# HARTING Product Change Notification

**PCN/22/008/PM+MD**

**Product range:** Board connectors / DIN Signal + har-bus 64

**Title:** Design change on DIN 41612 type R female - External

Design change on DIN 41612 type R female:

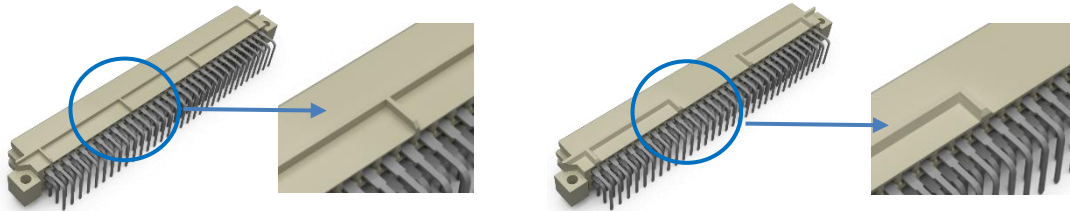
DIN 41612 type R female before ...

... and after change

The changes are purely concerning the top area of the isolation body. The ripples will be bigger and in the middle area of the connector the rip is removed. Background is an optimization of the molding process.

As part of the connectors can be used for reflow soldering process, we introduced a bigger flat area which allows to pick up the connector with a snozle in automatic pick and place process.
